Overview: The initial production release of the FTI-TLK1 harness has an issue where in some vehicles the secondary power input to the CN1 connector will overload the associated vehicle circuit, causing a fuse to blow. This issue affects the initial release of harnesses and is already being addressed in production. A field correction procedure is detailed below in Figure 1.

FTI-TLK1 Type 3B2 - Vehicle Coverage & Preparation Notes

FTI-TLK1 Type 3B2 - Installation Notes & Wiring Diagram

Figure 1: Step by step adapter correction

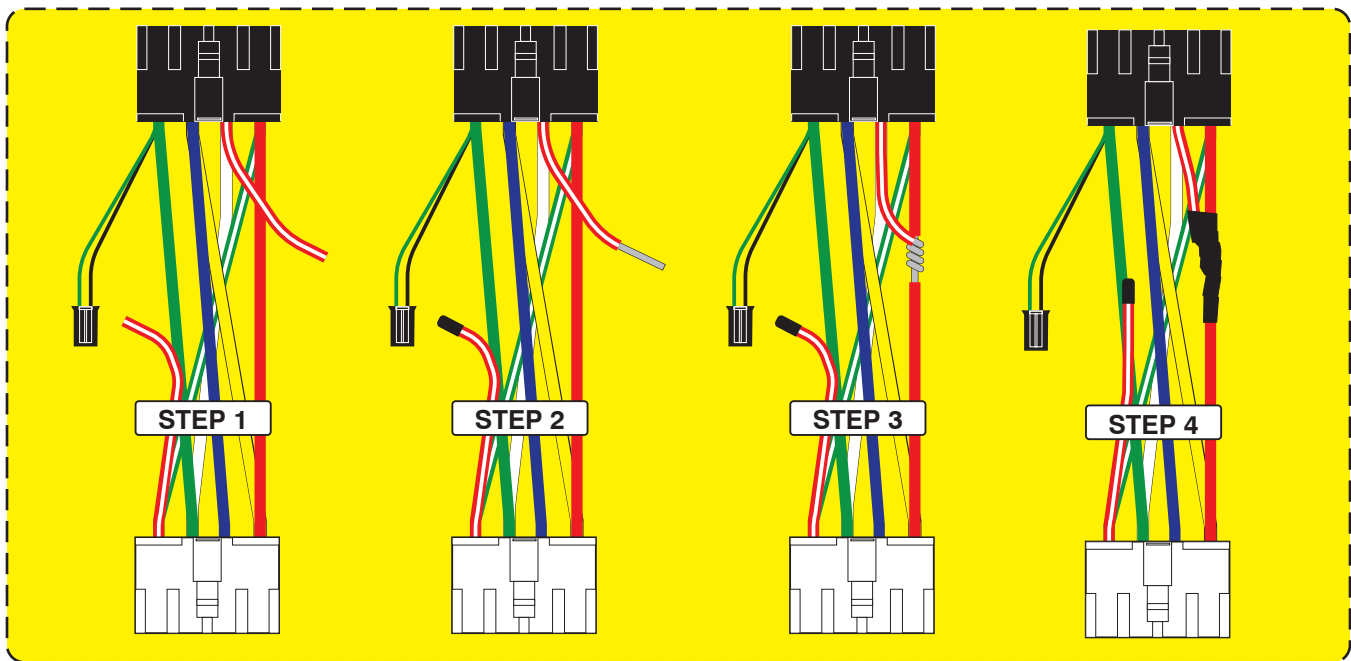
Issue: The secondary power circuit can overload some vehicle ignition switch circuits, causing a blown 5A/7.5A AM1 fuse, potentially disabling the vehicle and leaving the consumer stranded. Affected adapters are illustrated below in figure 2.

- 1.) Select the applicable CN1 adapter, isolate the RED/WHITE power wire, cut wire approximately 4" from the BLACK plug
- 2.) Insulate the wire still connected to the WHITE plug using heat shrink tubing, and strip the insulation on the other wire end
- 3.) Strip a portion of the insulation from the RED wire, attach the stripped RED/WHITE to the exposed RED wire, solder together
- 4.) Apply insulating tape to the soldered connection and secure the cut ends back to the bundle of wires created by the adapter
- 5.) Correction complete, you may safely proceed to finish your installation

Figure 2: Supplied CN1 Harness Adapters

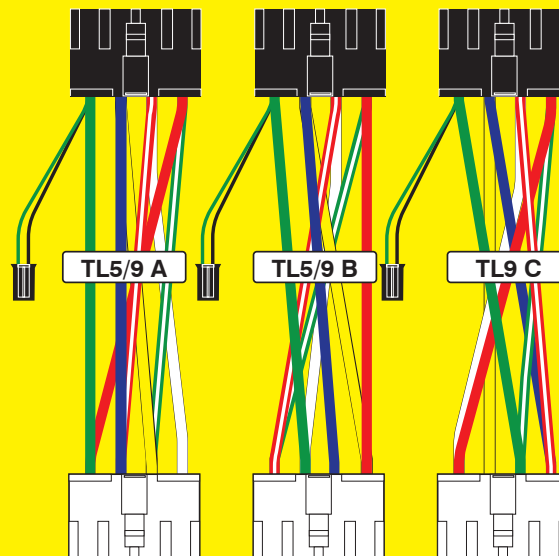
Incorrect power provisions with the potential to overload vehicle ignition supply circuit, resulting in blown AM1 fuse.
